SUMMARY OF U.S. NUCLEAR REGULATORY COMMISSION AND
U.S. DEPARTMENT OF ENERGY TECHNICAL EXCHANGE ON
VOLCANISM STUDIES

June 9, 1993, Las Vegas, Nevada

**NRC STAFF/CNWRA REVIEW OF THE
LANL VOLCANISM STATUS REPORT**

**NRC COMMENTS ON LANL REPORT
"STATUS OF VOLCANIC HAZARD STUDIES
FOR THE YUCCA MOUNTAIN SITE
CHARACTERIZATION PROJECT"**

*Compositional zonation does not require
polycyclic eruptions*

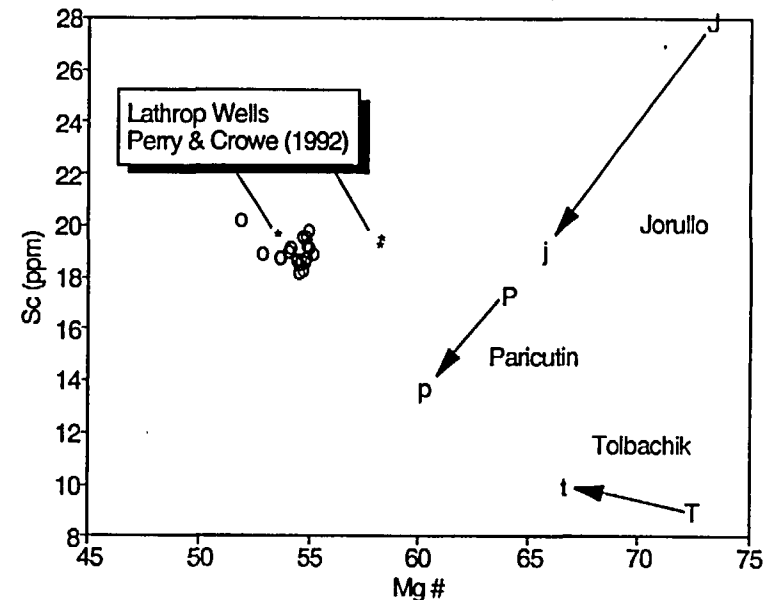
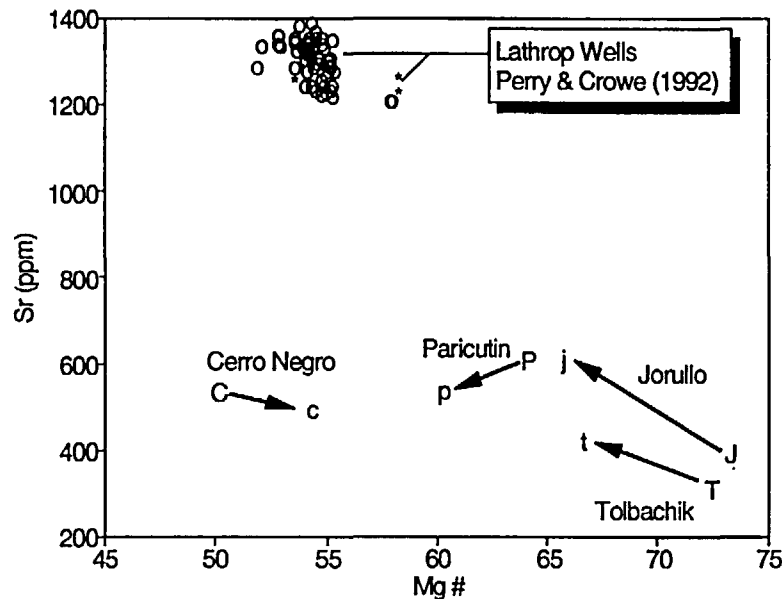
Historical, zoned mafic eruptions include:

- Tolbachik, Kamchatka (1975-76), 72 days
- Cerro Negro, Nicaragua (1971), 12 days
- Parícutin, Mexico (1943-1952), 9 years
- Jorullo, Mexico (1759-74), 15 years

*These eruptions each constitute a single event in the
geologic record and are considered monogenetic*

Normative Mineralogy

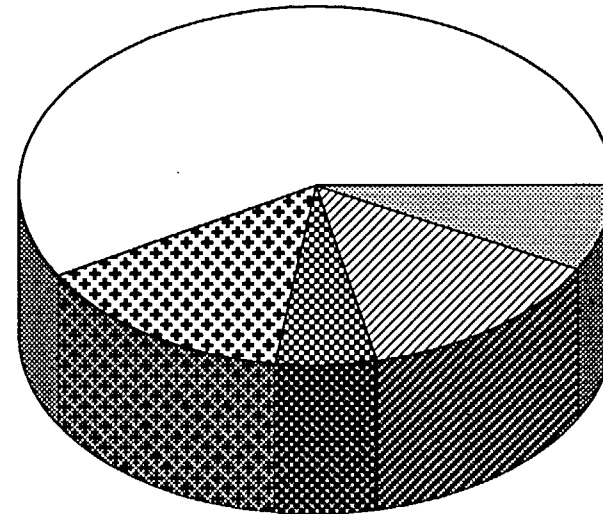
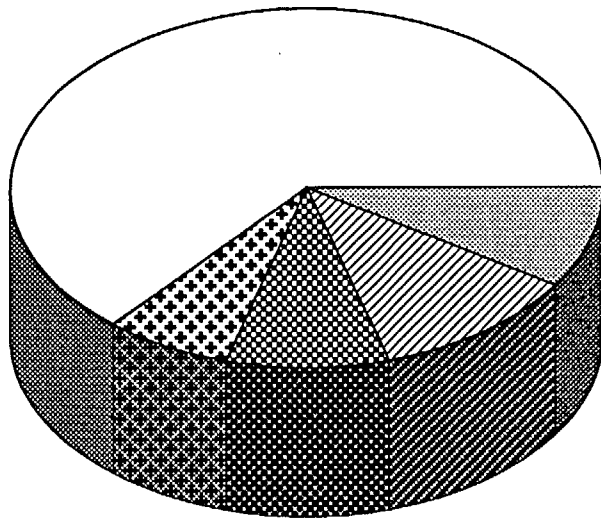
- Temperature
- Pressure
- Water Content
- Bulk Composition
- *All of these variables must be constrained before the effects of one variable can be identified*
- *Multiple hypotheses besides an increase in depth can explain changes in the Crater Flat basalt mineralogy*

Apparent problems in the mineralogy of Quaternary basalt

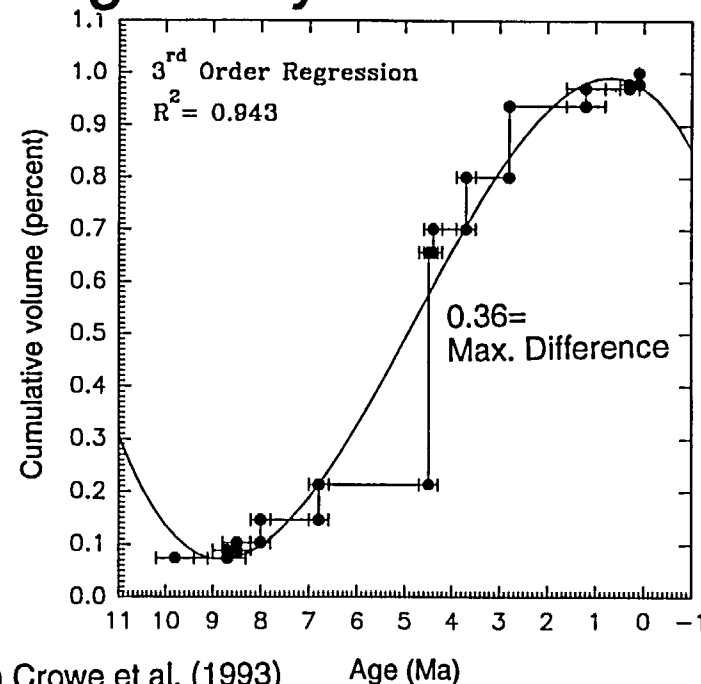
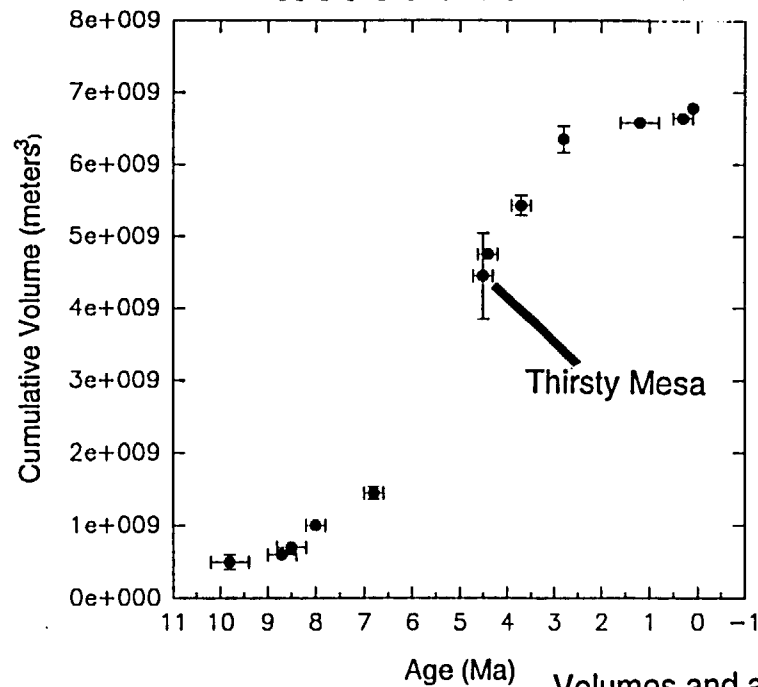
- Arguments for an increase in depth with time critically depend on the absence of plagioclase (e.g., p. 165). However:

"Lathrop Wells unit Ql₆ also contains plagioclase as a phenocryst phase" (p. 168)

At Lathrop Wells, U-Th dates utilize coarse and fine grained plagioclase in unit Ql₄ (p. 68)

Zreda et al. (1993) also report plagioclase phenocrysts at Lathrop Wells

The Western Great Basin is distinct from other Basin & Range magmatic provinces

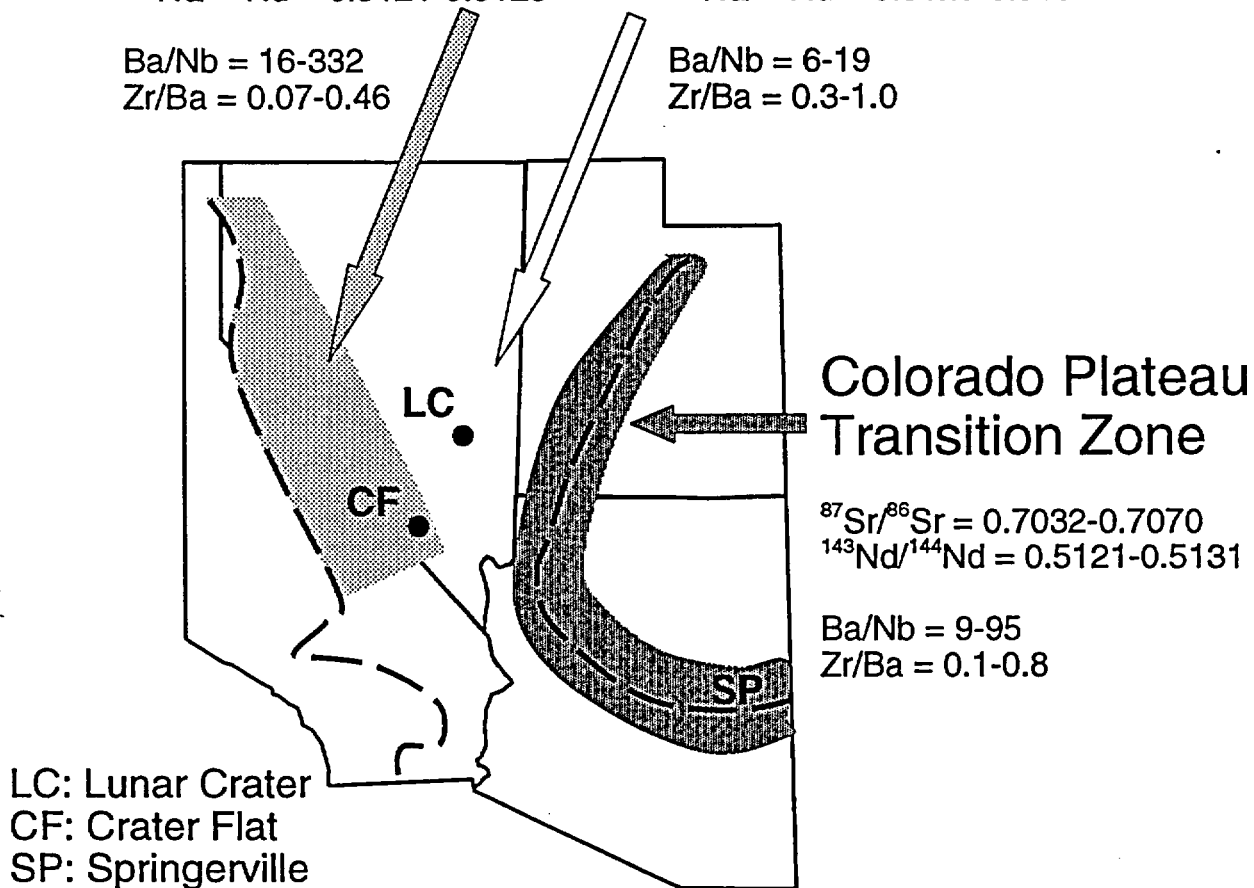
- WGB systems do not show distinct petrogenetic shifts at 5 Ma.
- WGB magmas still have lithospheric mantle signatures, <5 Ma B&R are asthenospheric
- CF is petrogenetically distinct from LC & SP systems & does not show a trend of waning magmatism

SOME ESTIMATES OF YMR RECURRENCE RATE

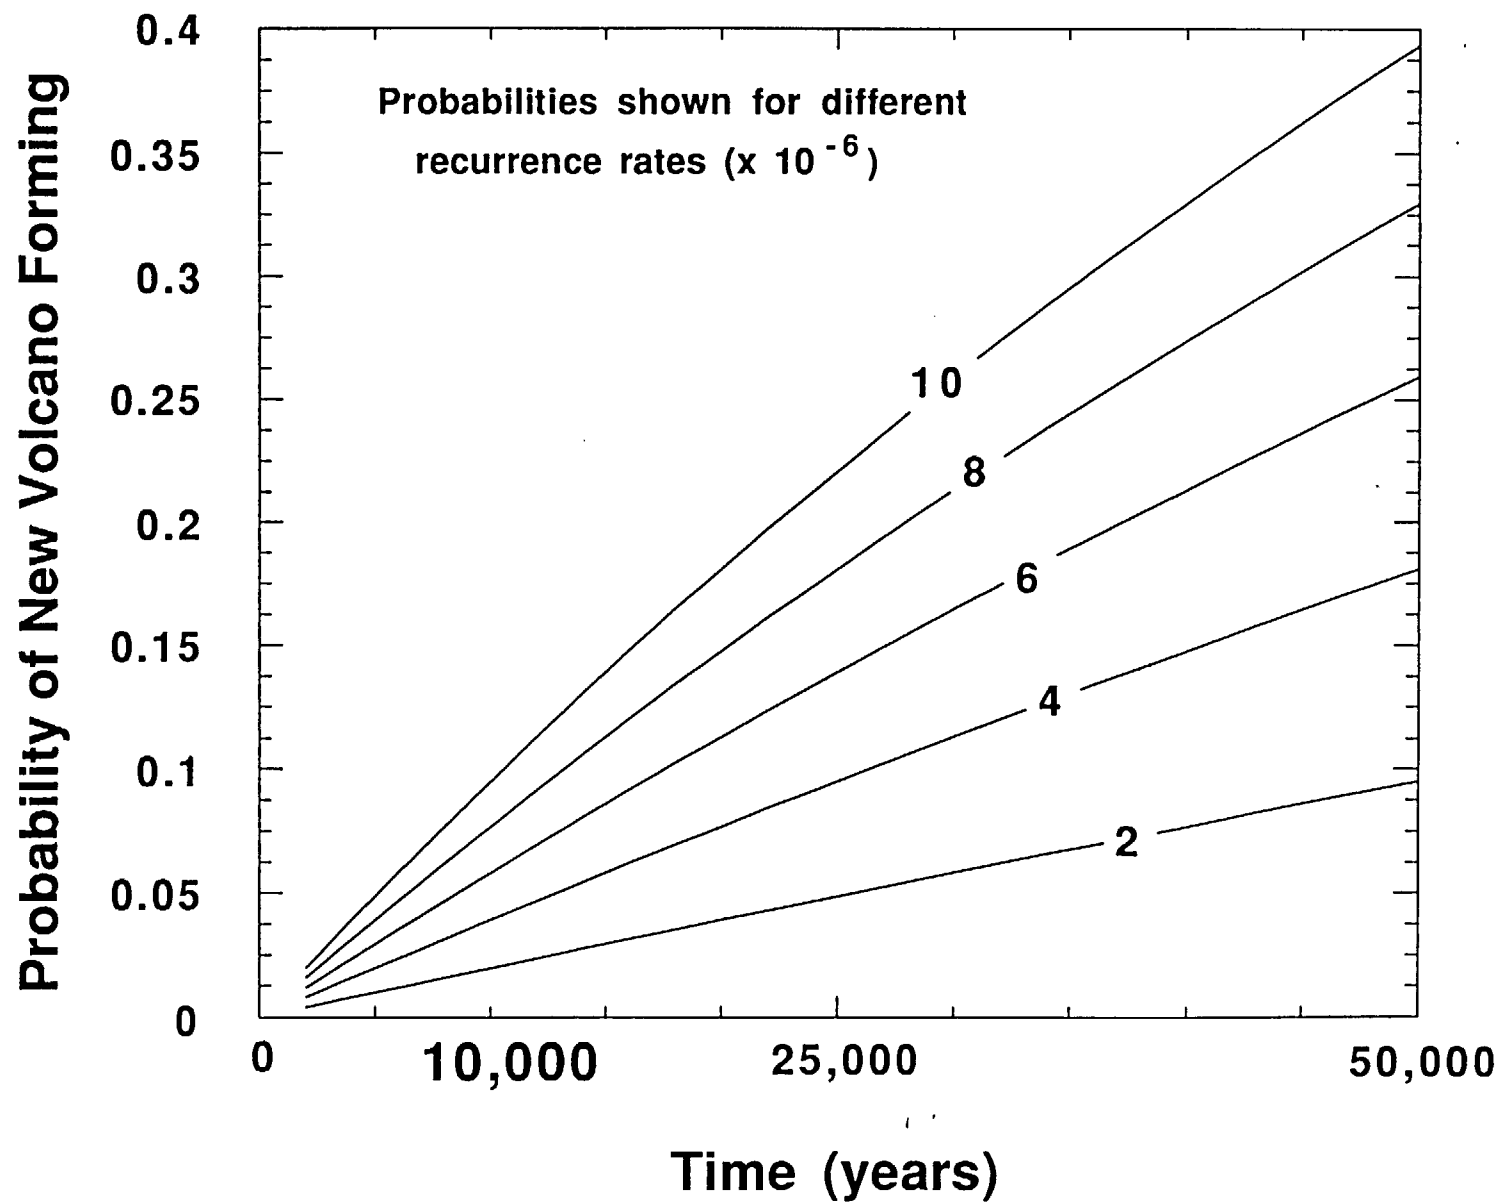
Given the uncertainty in the ages of Crater Flat volcanoes (1.2 ± 0.4 Ma), seven to eight volcanoes have formed in the last 0.8 to 1.6 million years. YMR recurrence rate is 7 ± 2 volcanoes / million years, based on time since start of Quaternary activity.

PROBABILITY OF DISRUPTION IN 10,000 yr USING NEAR NEIGHBOR NONHOMOGENEOUS POISSON MODEL

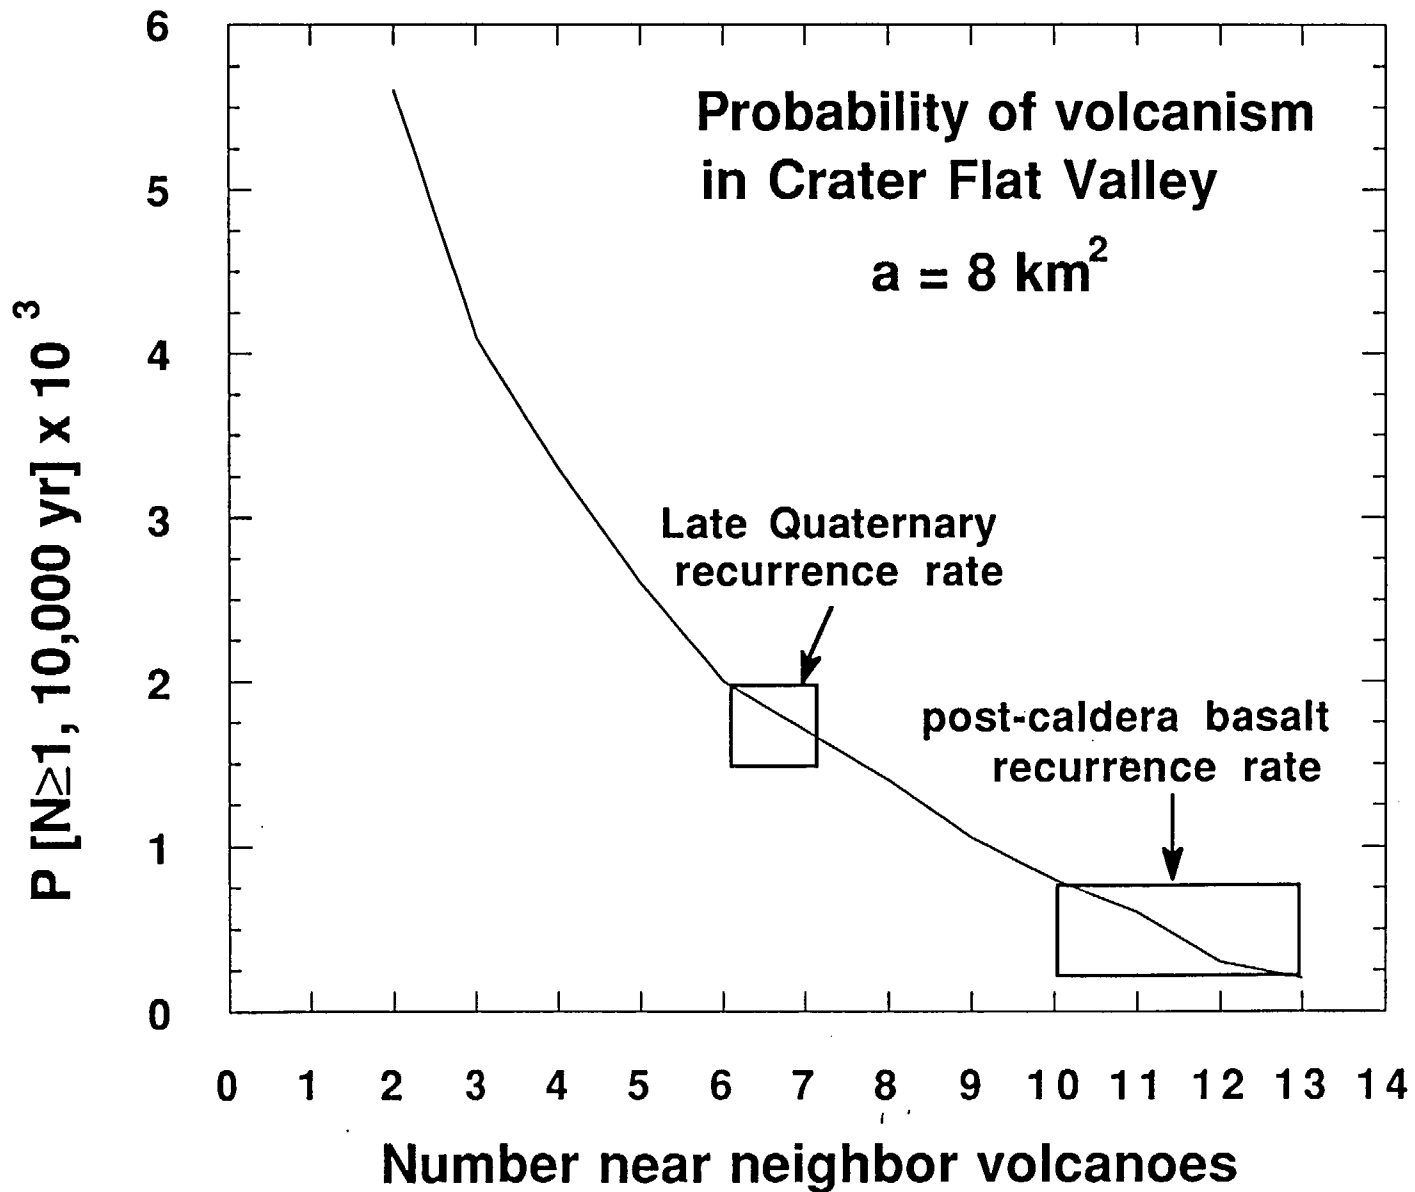
late Quaternary YMR recurrence rate:

$$8.0 \times 10^{-5} \text{ to } 3.5 \times 10^{-4}$$

with most estimates between 1×10^{-4} and 3×10^{-4}

post-caldera basalt YMR recurrence rate:

$$6.9 \times 10^{-5} \text{ to } 9.2 \times 10^{-5}$$

SIX NEAR NEIGHBOR NONHOMOGENEOUS POISSON PROBABILITY MODEL

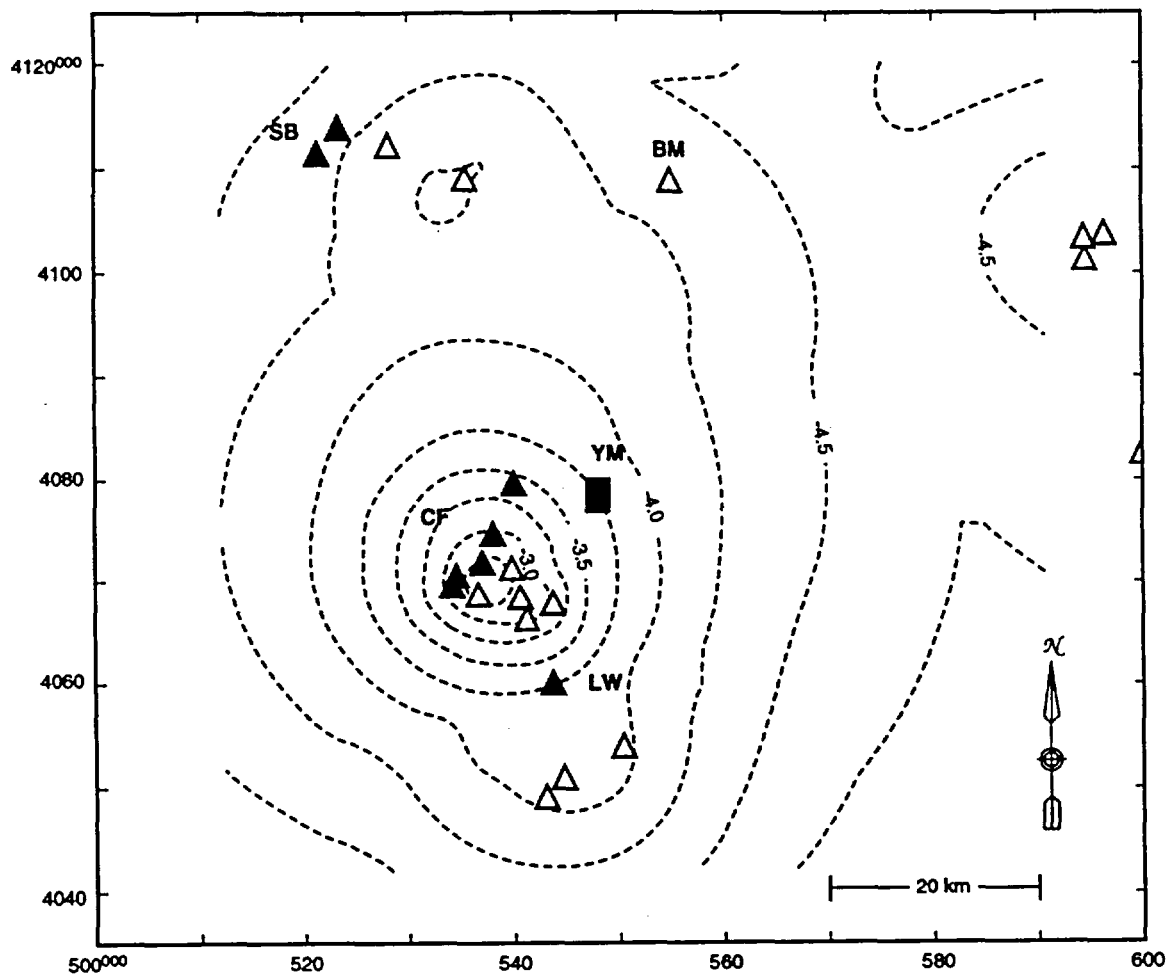
- Reflects late Quaternary recurrence rate (7 volcanoes / million years)
- Contour interval is $\text{Log}(P[N \geq 1, 10,000 \text{ yrs}, a = 8 \text{ km}^2])$ (e.g., -4.0 is a probability of 1 in 10,000 in 10,000 year of a new volcano forming within a 8 km² area)

TEN NEAR NEIGHBOR NONHOMOGENEOUS POISSON PROBABILITY MODEL

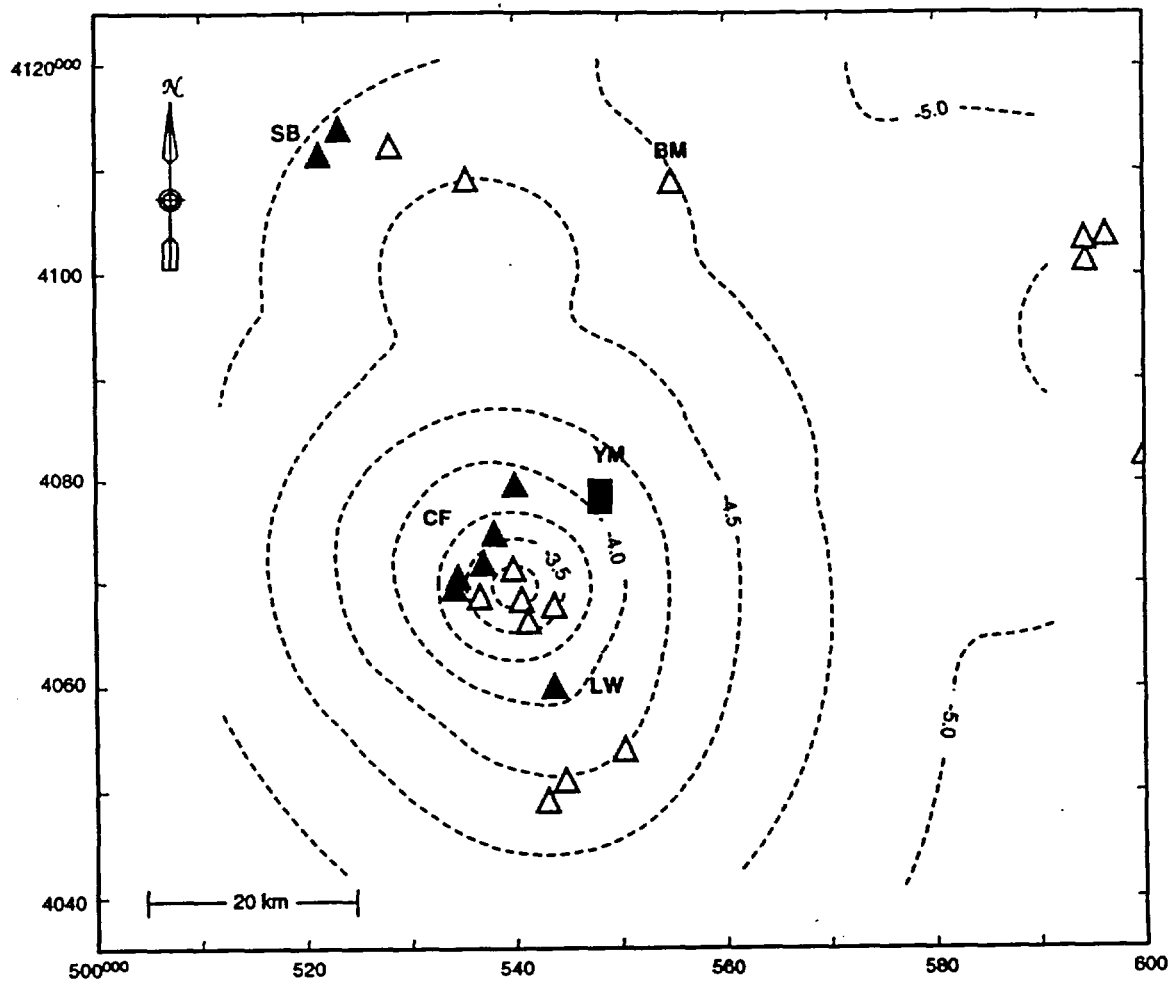
- Reflects post-caldera basalt recurrence rate (3 volcanoes / million years)
- Contour interval is $\text{Log}(P[N \geq 1, 10,000 \text{ yrs}, a = 8 \text{ km}^2])$ (e.g., -4.0 is a probability of 1 in 10,000 in 10,000 year of a new volcano forming within a 8 km² area)

(b)

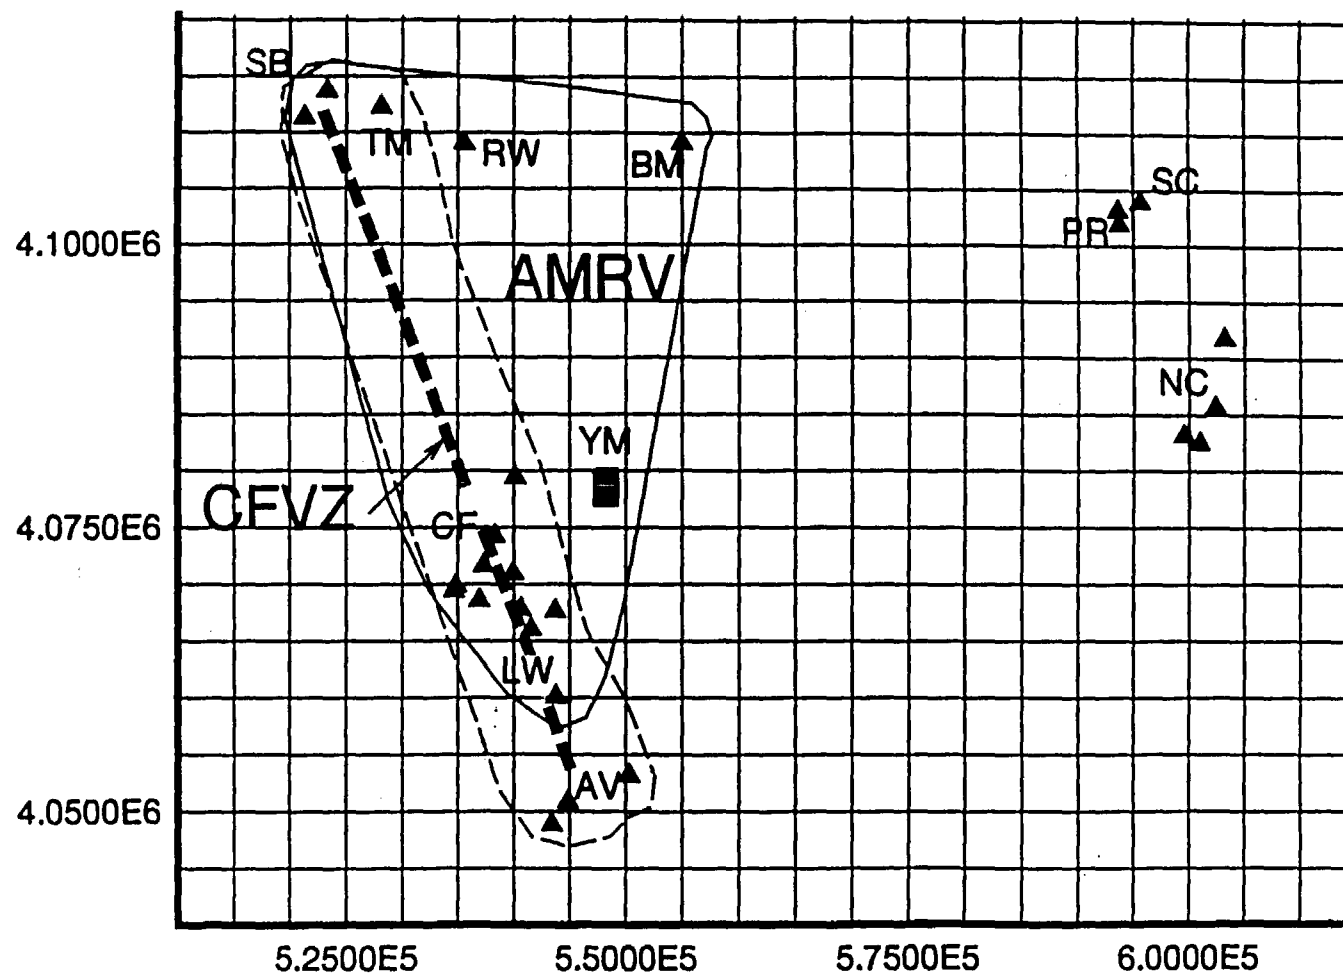
REGRESSION ANALYSIS IN THE CFVZ IS CONTROLLED BY SLEEPING BUTTE CLUSTER. THE RESULTING CORRELATION COEFFICIENT IS SPURIOUSLY HIGH.
